Operator: **Extraction Oil & Gas, Inc.**
Location Name: **ALMA 1S-66-2524**
Loc ID: **449925**
Inspection: **709400008**

Exhibit A

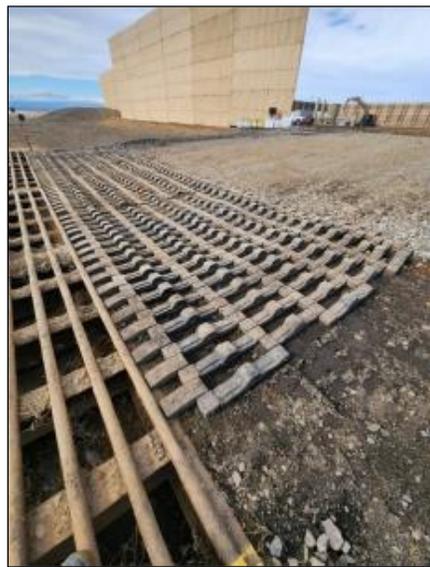
CA: Tracking pad not adequately maintained to prevent track of material offsite. Refer to inspection photos for documentation.
Corrective Action Maintain vehicle tracking BMPs on the oil and gas location to comply with rule 1002.f. (2)F

CA Resolution: Tracking pads at entrance were cleaned and are now in compliance with rule 1002.f. (2)F.
